SUBJECT: NORTH ANNA POWER STATION, UNITS 1 AND 2 - ISSUANCE OF
AMENDMENTS AND EXEMPTION FROM THE REQUIREMENTS OF
10 CFR PART 50, SECTION 50.60(a) RE: AMENDED PRESSURE-
TEMPERATURE LIMITS (TAC NOS. MA9343, MA9344, MA9347, AND MA9348)

Amendment No. 226
License No. NPF-4

Amendment No. 207
License No. NPF-7

SAFETY EVALUATION BY THE OFFICE OF NUCLEAR REACTOR REGULATION
RELATED TO THE PRESSURE-TEMPERATURE LIMITS AND LOW TEMPERATURE
OVERPRESSURE PROTECTION SYSTEM FOR
NORTH ANNA POWER STATION UNITS 1 AND 2
VIRGINIA ELECTRIC AND POWER COMPANY (VEPCO)
DOCKET NOS. 50-338 AND 50-339

Figure 3.4-2

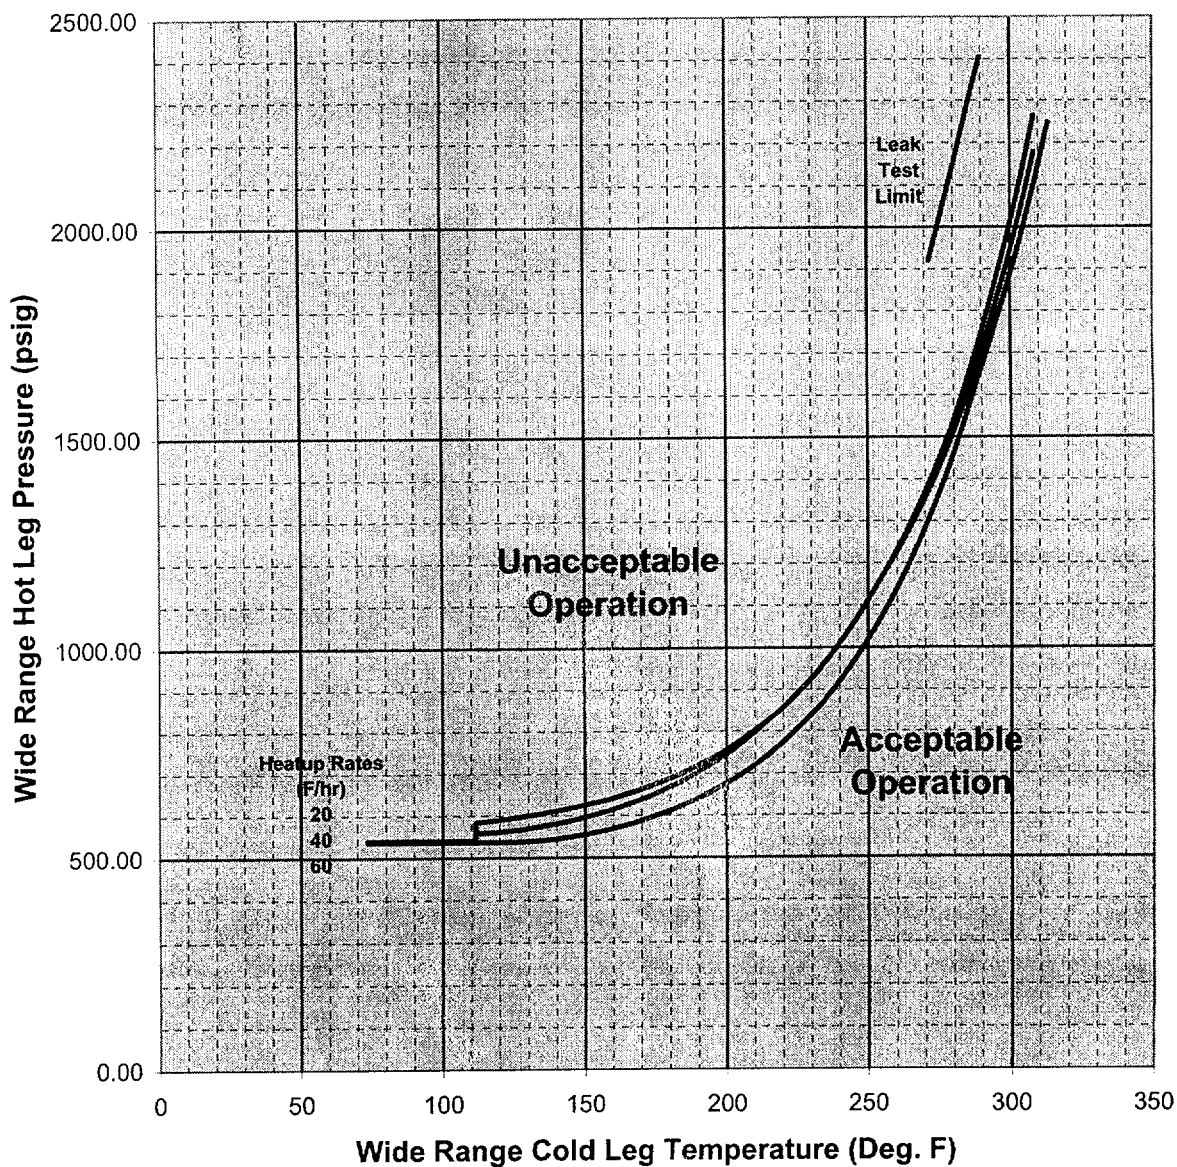
The heatup limit curve, Figure 3.4-2, is a composite curve which was prepared by determining the most conservative case, with either the inside or outside wall controlling, for any heatup rate up to 60°F per hour. The cooldown limit curves of Figure 3.4-3 are composite curves which were prepared based upon the same type analysis with the exception that the controlling location is always the inside wall where the cooldown thermal gradients tend to produce tensile stresses while producing compressive stresses at the outside wall. The heatup and cooldown curves of Figures 3.4-2 and 3.4-3 are based upon a 1/4-T RT_{NDT} value of 218.5°F and a 3/4-T RT_{NDT} value of 195.6°F. These RT_{NDT} values conservatively bound the predicted reactor vessel beltline RT_{NDT} values for North Anna Unit 1 operation through 32.3 EFPY. The heatup and cooldown limits include margins to accommodate pressure and temperature measurement uncertainty, and the pressure difference between the point of measurement (RCS hot leg) and the point of interest (reactor vessel beltline).

The pressure-temperature limit lines shown on Figure 3.4-2 for inservice leak and hydrostatic testing have been provided to assure compliance with the minimum temperature requirements of Appendix G to 10 CFR 50. The minimum temperature for criticality specified in T.S. 3.1.1.5 assures compliance with the criticality limits of 10 CFR 50 Appendix G.

Limiting ART at 32.3 EFPY: 1/4-T, 218.5 deg. F

3/4-T, 195.6 deg. F

Figure 3.4-2

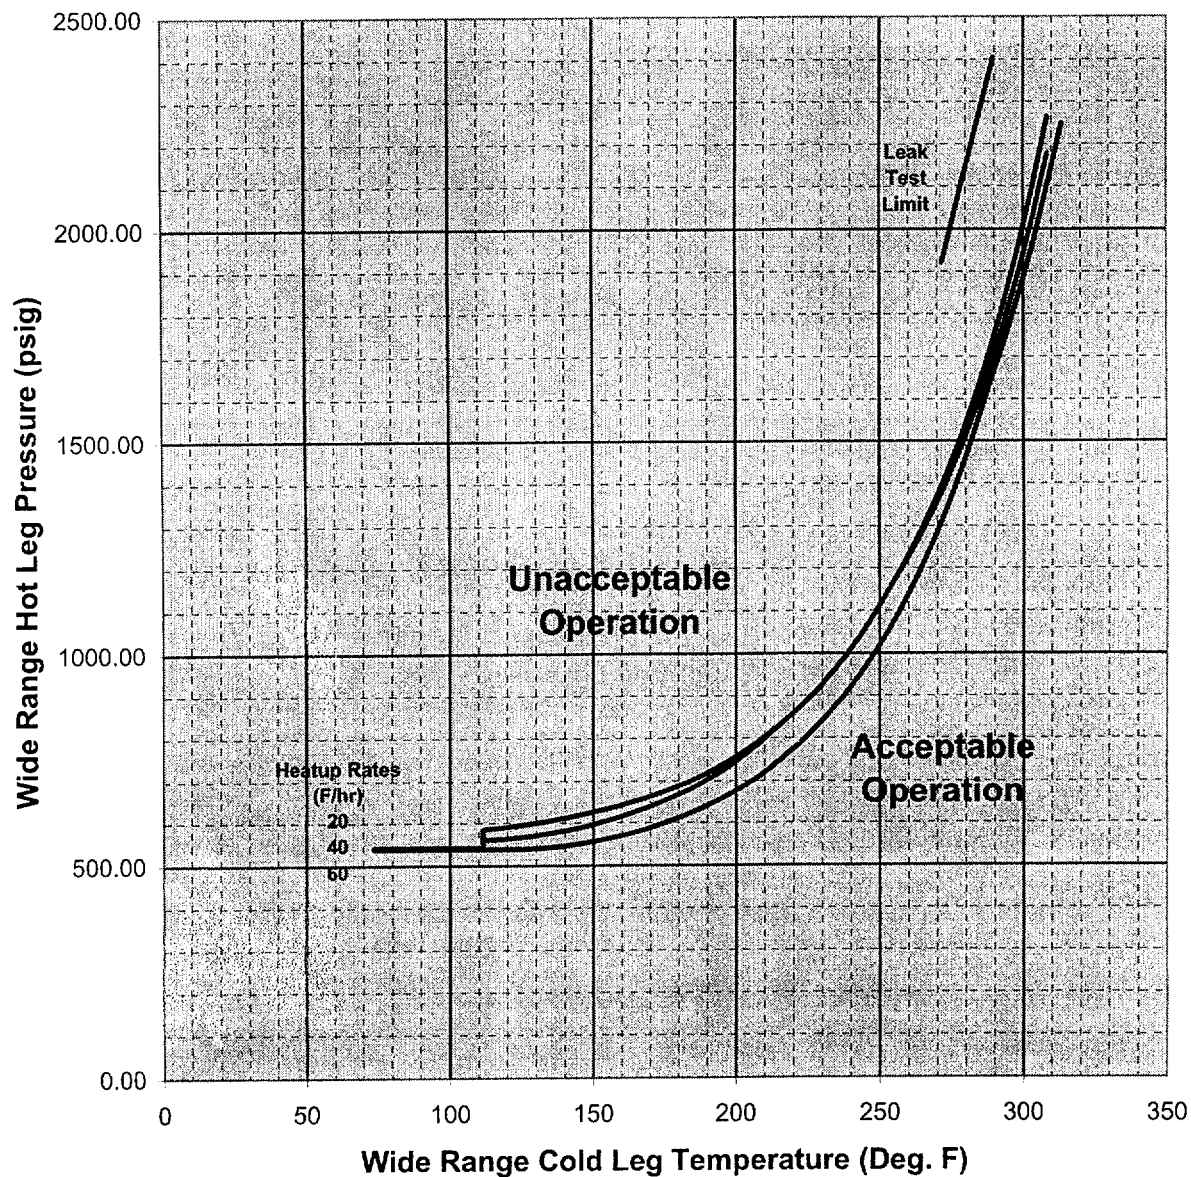
The heatup limit curve, Figure 3.4-2, is a composite curve which was prepared by determining the most conservative case, with either the inside or outside wall controlling, for any heatup rate up to 60°F per hour. The cooldown limit curves of Figure 3.4-3 are composite curves which were prepared based upon the same type analysis with the exception that the controlling location is always the inside wall where the cooldown thermal gradients tend to produce tensile stresses while producing compressive stresses at the outside wall. The heatup and cooldown curves of Figures 3.4-2 and 3.4-3 are based upon a 1/4-T RT_{NDT} value of 218.5°F and a 3/4-T RT_{NDT} value of 195.6°F. These RT_{NDT} values conservatively bound the predicted reactor vessel beltline RT_{NDT} values for North Anna Unit 2 operation through 34.3 EFPY. The heatup and cooldown limits include margins to accommodate pressure and temperature measurement uncertainty, and the pressure difference between the point of measurement (RCS hot leg) and the point of interest (reactor vessel beltline).

The pressure-temperature limit lines shown on Figure 3.4-2 for inservice leak and hydrostatic testing have been provided to assure compliance with the minimum temperature requirements of Appendix G to 10 CFR 50. The minimum temperature for criticality specified in T.S. 3.1.1.5 assures compliance with the criticality limits of 10 CFR 50 Appendix G.

Limiting ART at 34.3 EFPY: 1/4-T, 218.5 deg. F

3/4-T, 195.6 deg. F
